Illinois Tollway M-ITS Base Sheet Revisions

Section M Base Sheet Drawings		
Drawing	Modification Summary	Effective: 2021-03-01
	New Sheet Retired Standard	
Pole Assembly (ITS)-Series 1000		
M-ITS-1000	Elevation Views Pole Mounted ITS Element Assembly	
	<ul style="list-style-type: none"> . Sheet 1of3: Added title for one section detail; Added note on wires from solar panels to battery box then to ITS enclosure then Cat6 cables to ITS devices installed on the ITS pole . Sheet 2of3: Added title for ITS Disconnect Switch Cast-in place . Sheet 3of3: Added new assembly detail for ITS Disconnect Switch Pre-cast (simplified installation) 	
M-ITS-1001	General Notes Pole Mounted ITS Element Assembly	
	<ul style="list-style-type: none"> . Added Note 22.: Cables shall enter poles through a gromet. Gromet size shall be chosen so that the center hole forms a water tight seal around the cables 	
Dynamic Message Sign (ITS)-Series 1100		
M-ITS-1103	DMS Front Access-Cantilever Electrical Plan

Illinois Tollway Base Sheet Revisions
--

SIMPLIFIED ITS POLE SOLAR ARRANGEMENT
 NOT TO SCALE

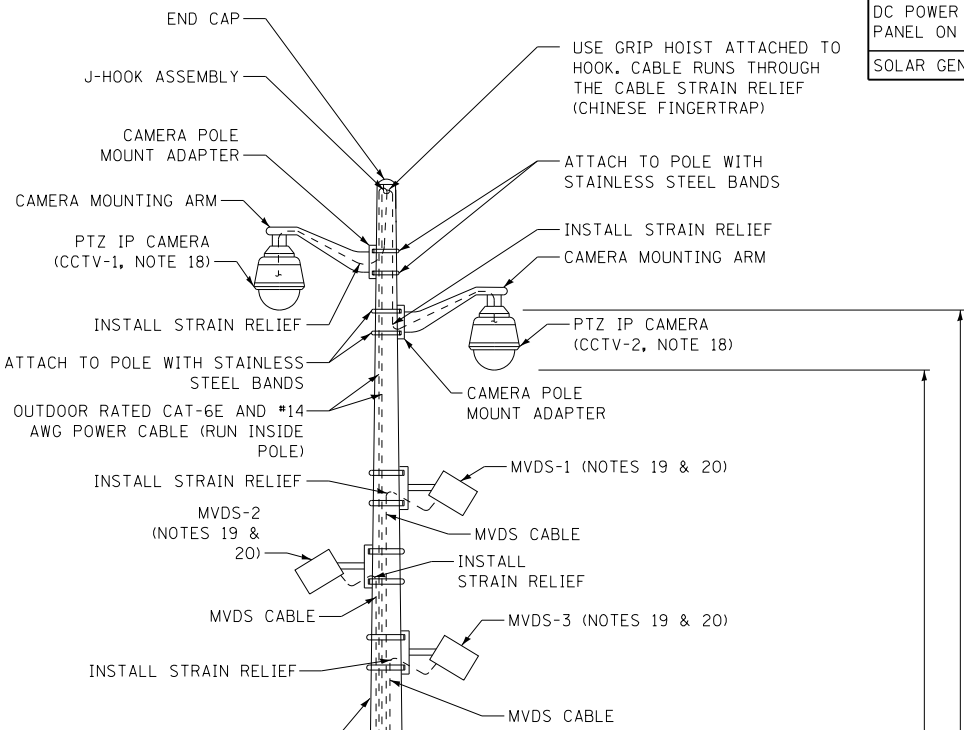
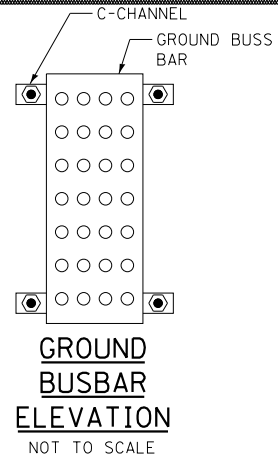
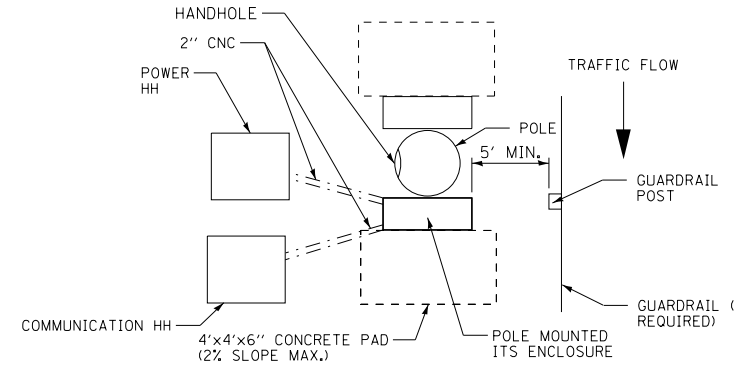
Section M Base Sheet Drawings	
Drawing	Modification Summary
Effective: 2020-03-01	
Solar Powered Generator (ITS)-Series 1400	
M-ITS-1400	Solar Power Generator Details
	. Added Note to Designer: The simplified solar power arrangement shall only be used for a maximum of 3 MVDS. For all other arrangements use the 1400 Series
Tower Mounted CCTV (ITS)-Series 1500	
M-ITS-1500	ITS Details Tower Mount Camera Details
	. Added note to Designer: The 2 CCTV shall be placed on the leg facing the roadway with a clear field of view . Added Note 23: The CCTV cameras shall be mounted on the same tower leg with an Axis T92B62 mounting arm with T94A01D pendant kit, or equivalent as approved by the engineer. There will be 24in vertical spacing between the cameras
M-ITS-1503	. Removed details for Part AS: removed PoE power injector . Remove Item AS: removed reference to Cohu PoE injector
Flashing Sign Beacon (ITS)-Series 1700

NOTE 3 TO DESIGNER
 THE SIMPLIFIED SOLAR POWER ARRANGEMENT SHALL ONLY BE USED FOR A MAXIMUM OF 3MVDS. FOR ALL OTHER ARRANGEMENTS USE THE 1400 SERIES.

CABINET LAYOUT AND WIRING
ITS POLE MOUNTED ENCLOSURE
(SOLAR POWERED 1-MVDS)

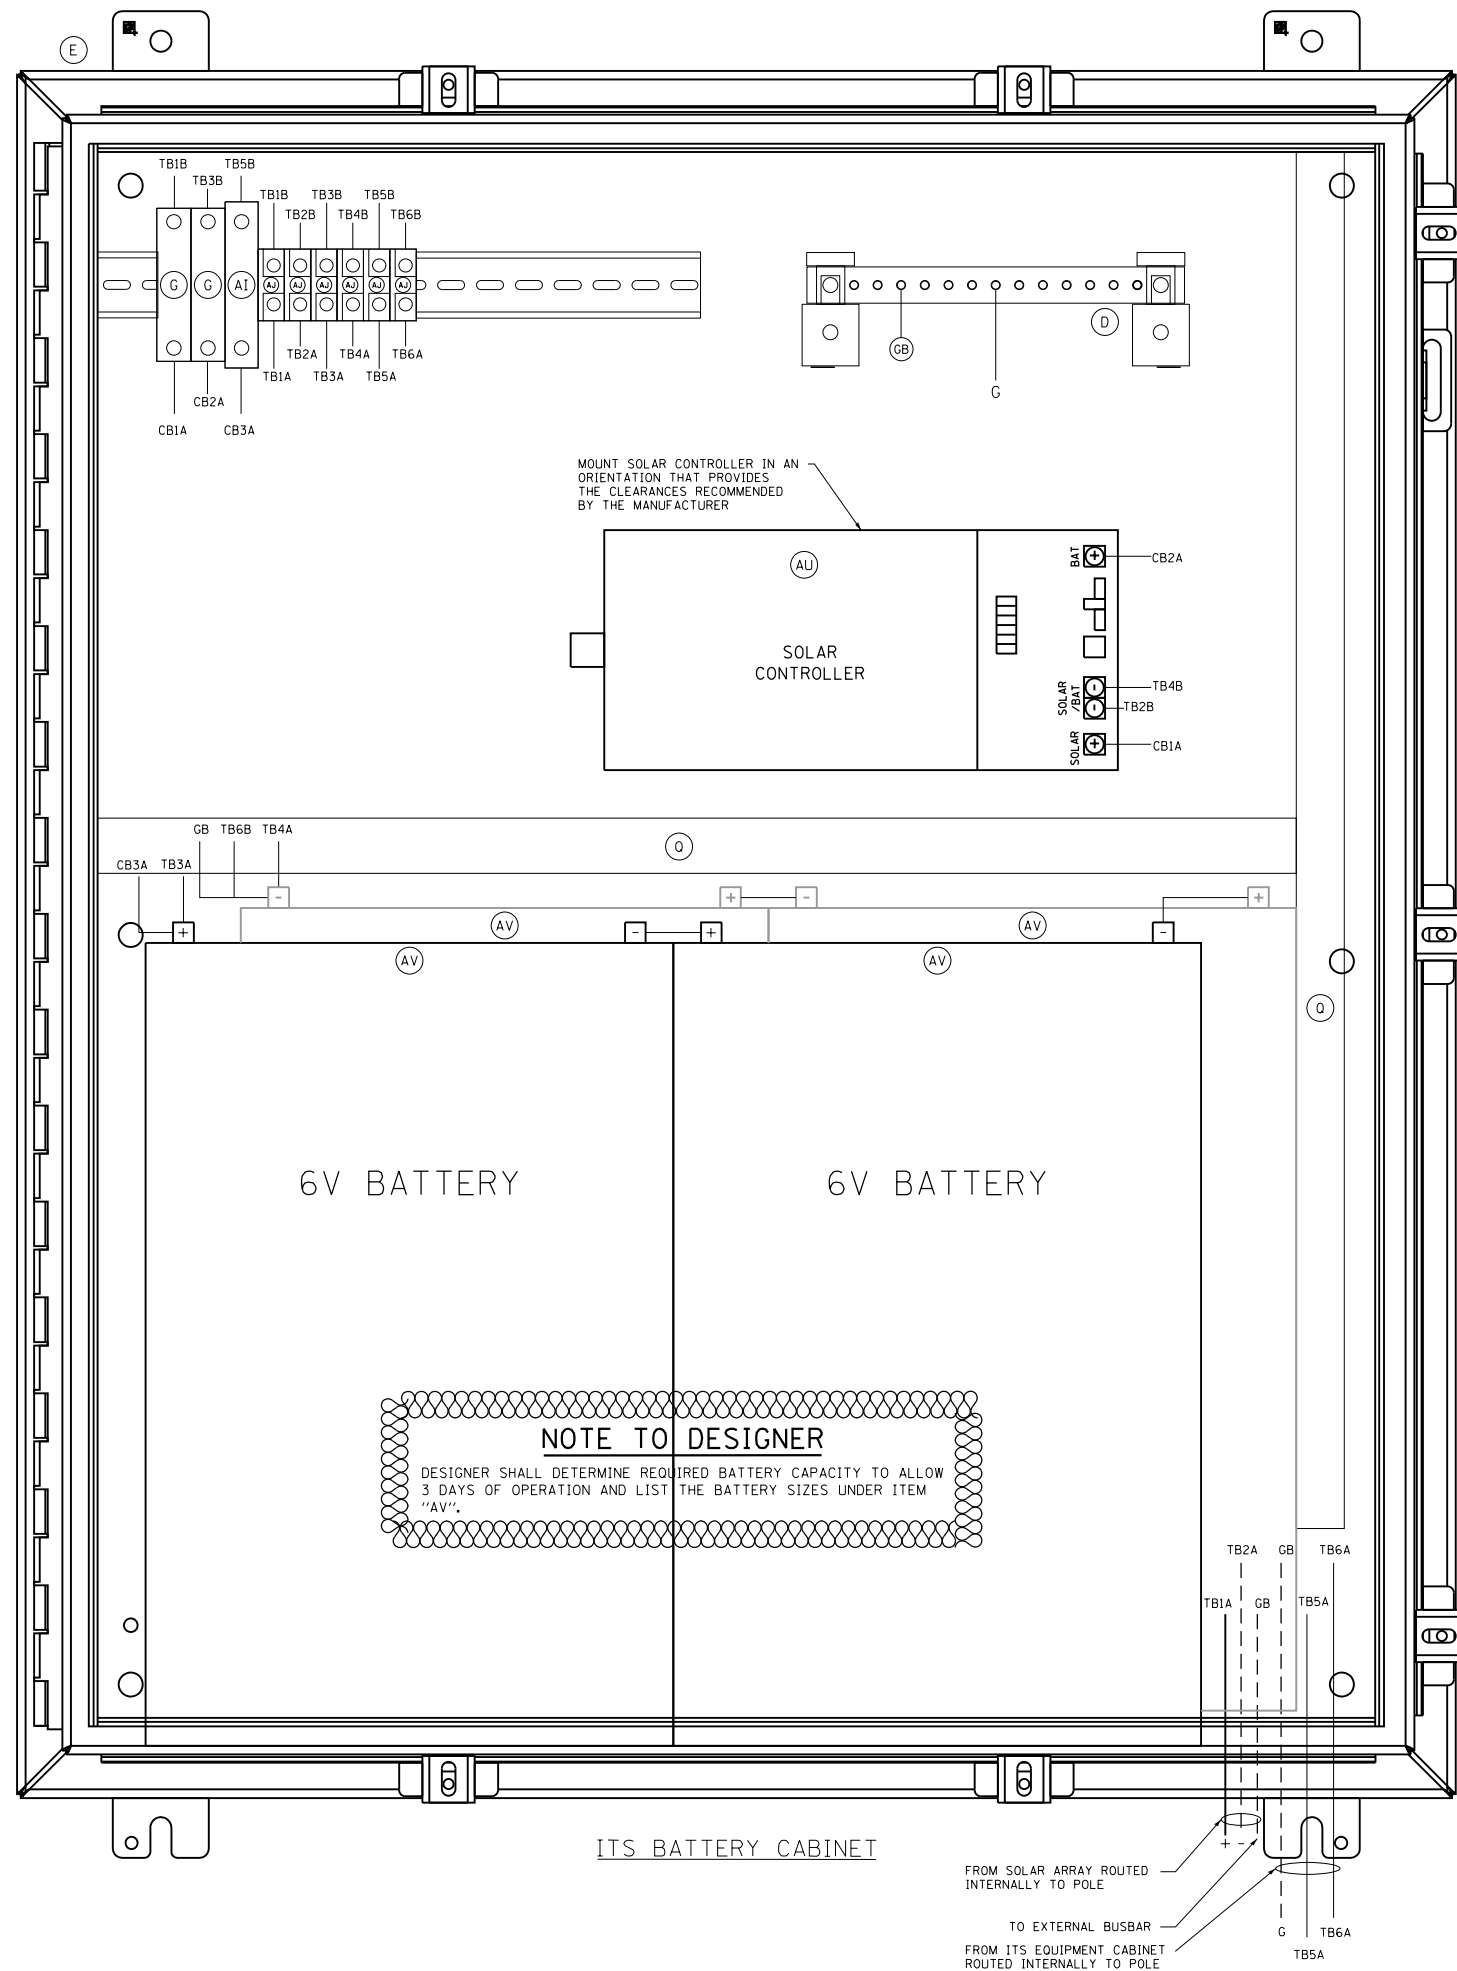
<ul style="list-style-type: none"> . Revised to show the fiber optic conduit and power conduit interface with the ITS Enclosure for location and size . Added Note 13: Fiber cable shall run straight down from the Gator patch through the left most conduit. Power cable shall be pulled through the conduit to the right of the fiber conduit. No slack shall be placed in the cabinet, slack shall be put in power and fiber optic handholes . Revised layout to remove Cohu Surge Suppressor Part AS . Revised details for Part V to remove dash line for DITEK surge suppressor . Revised description for Item V to remove Cohu camera . Revised Item AQ to remove reference to Cohu PoE power injector . Remove Item AS for Cohu PoE injector not required anymore . Revised Note 4: to say Not used 	
M-ITS-1217	Cabinet Wiring Diagram In Pavement Detection System AP, PoE and Injector ITS Assembly	
	<ul style="list-style-type: none"> . Revised to show the fiber optic conduit and power conduit interface with the ITS Enclosure for location and size . Added Note 13: Fiber cable shall run straight down from the Gator patch through the left most conduit. Power cable shall be pulled through the conduit to the right of the fiber conduit. No slack shall be placed in the cabinet, slack shall be put in power and fiber optic handholes . Added Note to Designer: The DSE shall specify the Gator Patch length per site
